New Spindle

Subject: Replacement spindle for 71460092 and 71460057

Affected: WZ and WSE s/n 39286 and below, WSR and WSES s/n 43612 and below.

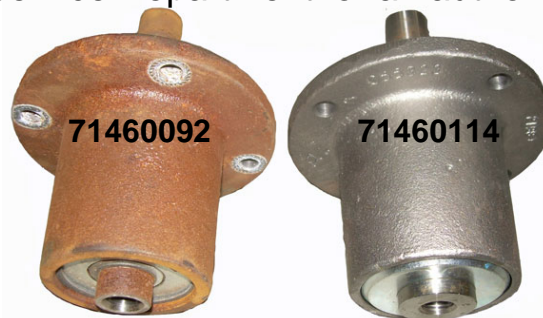
Situation: The 71460092 Spindle shaft was failing prematurely. A new spindle has been developed.

A new spindle has been developed (71460114). If a unit is brought in for service in regards to spindles and has 71460092 spindles installed, (Identified in figure below) **all** spindles will be replaced (regardless of failure).

- If a unit is brought in for spindle service and 71460057 spindles are installed then only replace the bad spindle (**DO NOT REPLACE ALL SPINDLES**)
- All 71460092 spindle inventory should be discarded. Contact your Distributor with new in stock quantities (if applicable) for credit.
- All inventories of 71460057 spindles are to be depleted.
- Units out of warranty with 71460092 spindles will be covered for parts only for an additional year. Distributors must email WMI Service Department for an authorization number.
